To:	Stephanie Carr, US EPA
From:	Robert Drake
Date:	June 19, 2007
Subject:	Proposed Revision to Scope of Work to Address US EPA Comments (04/06 Draft Correspondence) ERM Project No. 0059195

Revised Work Plan

Figure 2 - Proposed Geophysical Survey
80 Pickett District Road, New Milford, CT

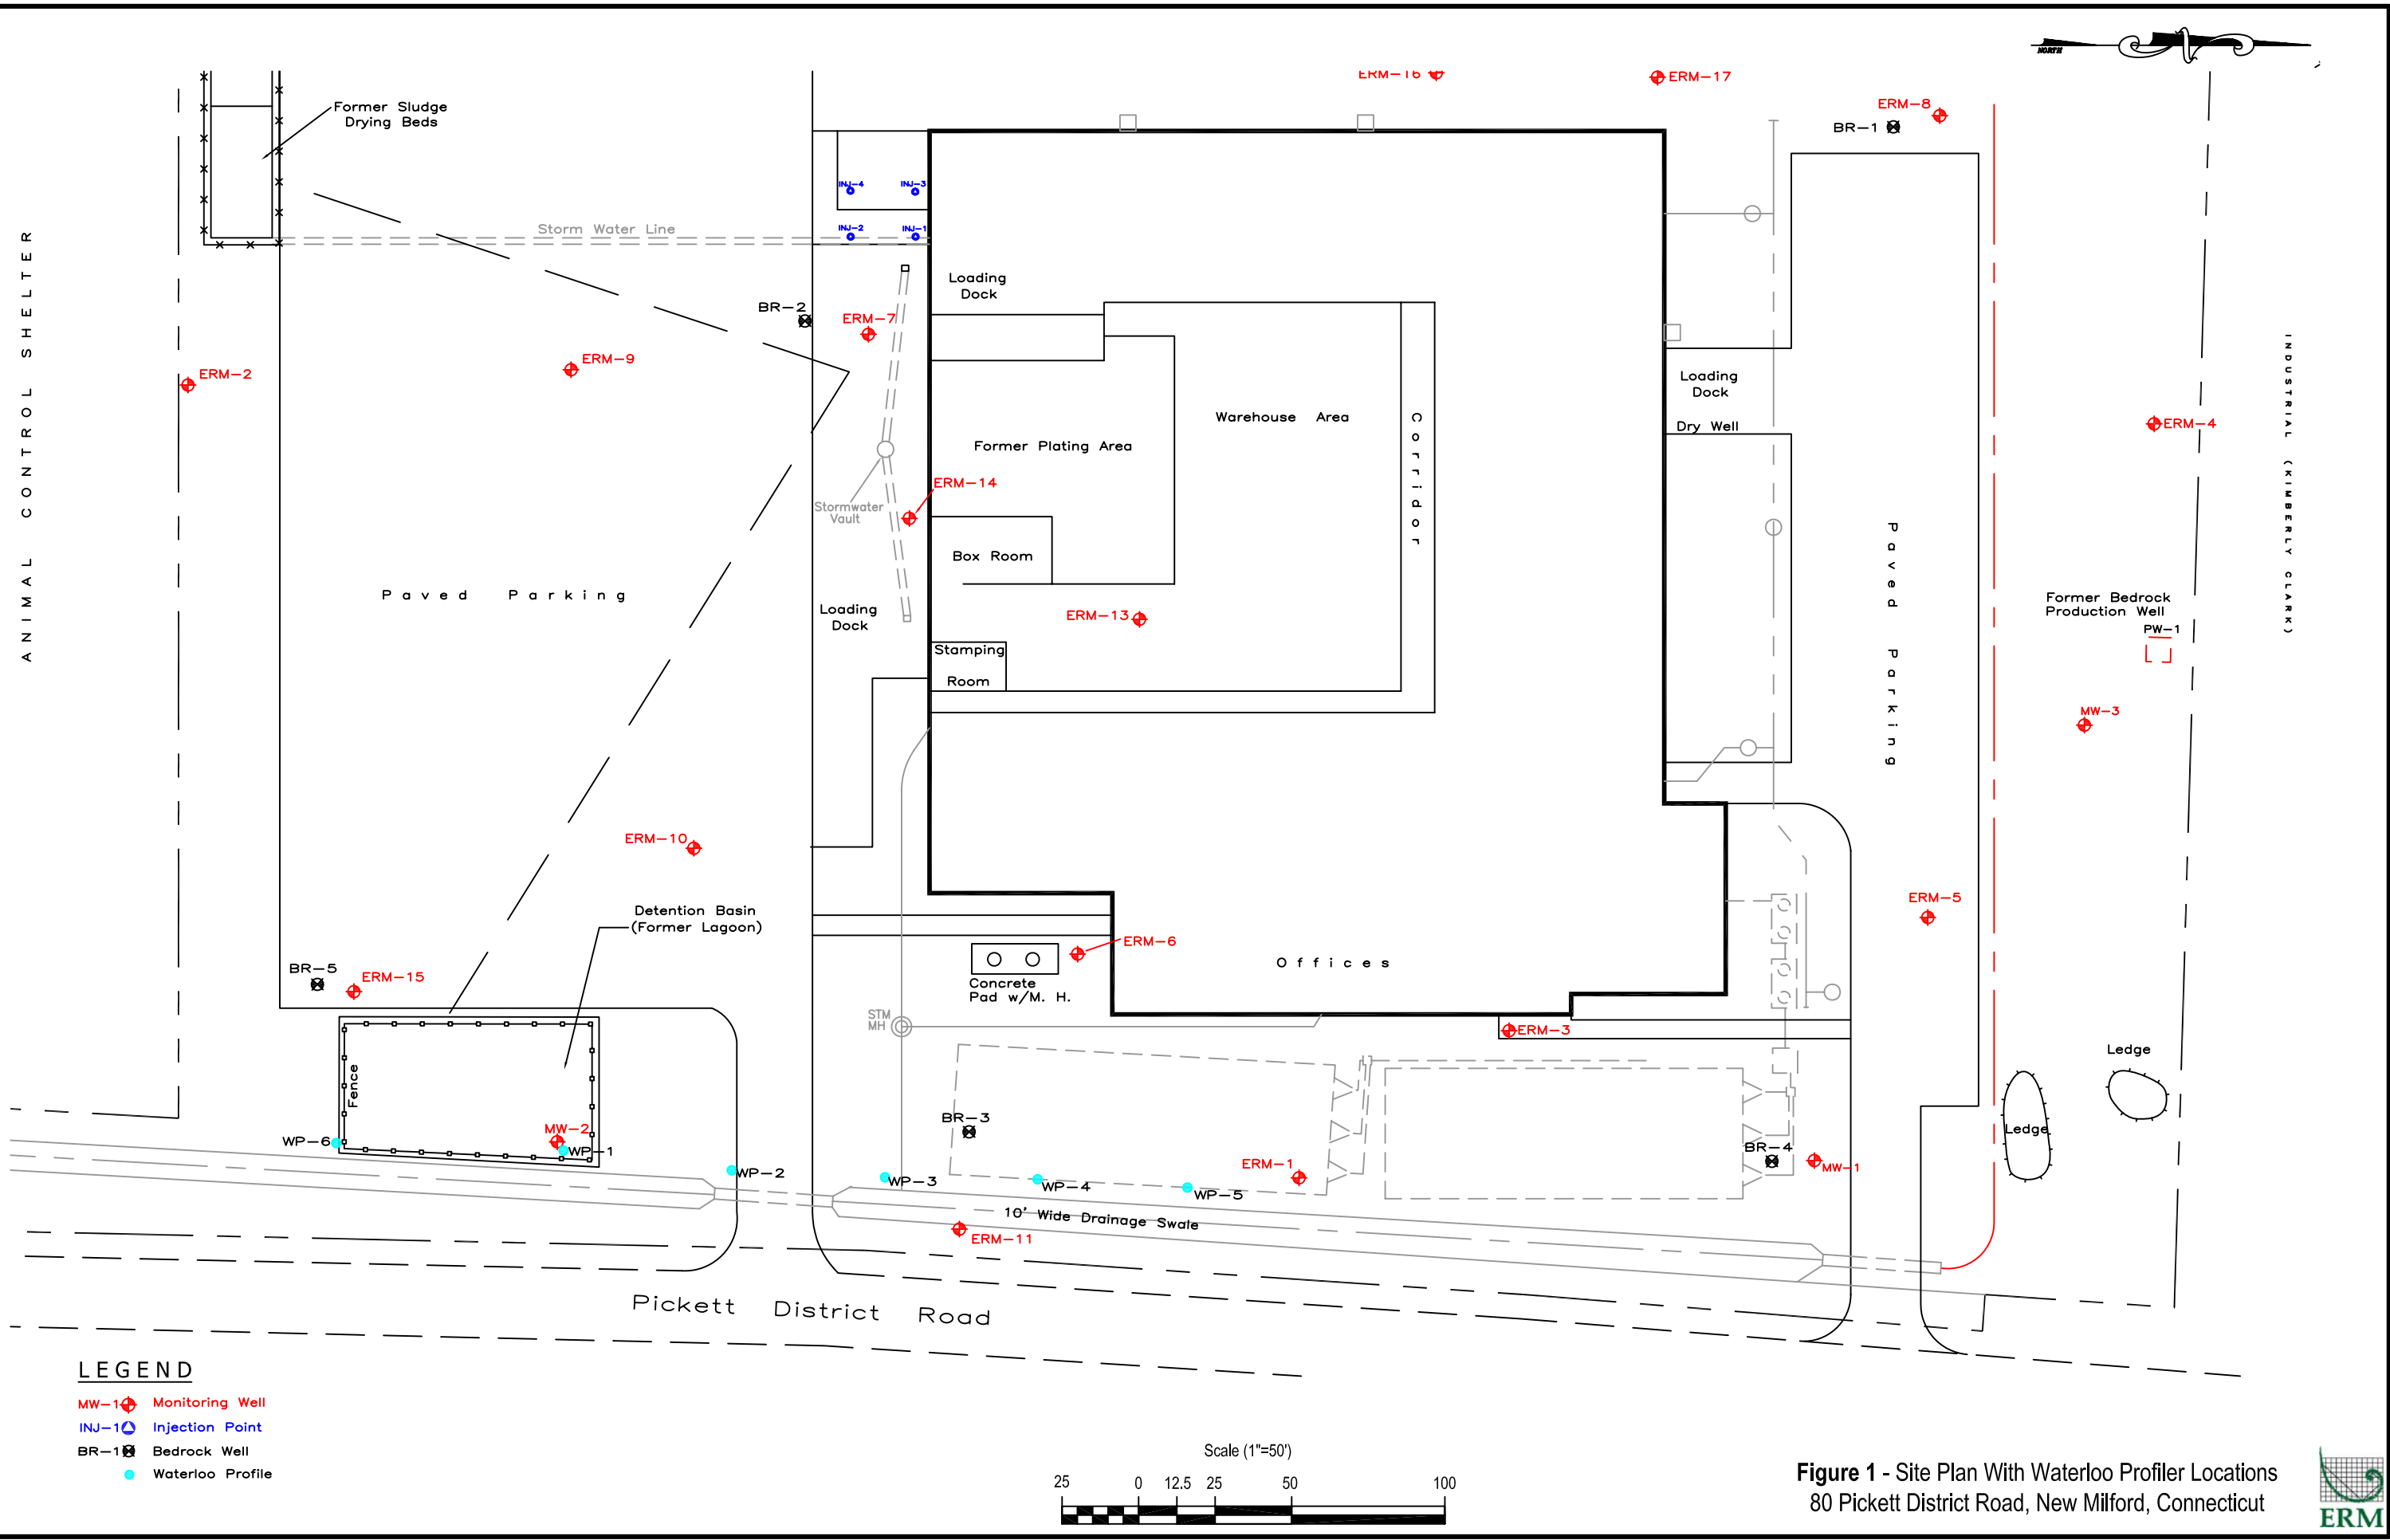
A series of three (3) north/south transects will be performed, using a surface geophysics program [i.e., seismic refraction (SR) and/or two-dimensional (2D) resistivity] to define the bedrock-overburden contact along three 300-foot long, parallel, north-south trending transects to map

the bedrock surface. The transects would be situated as follows (see Figure 2):

- Transect 1 – located along the western side of Pickett District Road, starting at the southeast corner of the property, and extending south 300 feet towards the intersection with Dodd Road;
- Transect 2 – located approximately 500 feet southeast of Transect 1, starting near the northern property boundary of the ACH Retail Products (ACH) facility, located at 87 Pickett District Road, and running south for approximately 300 feet; and
- Transect 3 – located approximately 1,500 feet southeast of Transect 2, at the eastern boundary of the ACH property, alongside the existing railway tracks, running north/south for a length of approximately 300 feet.
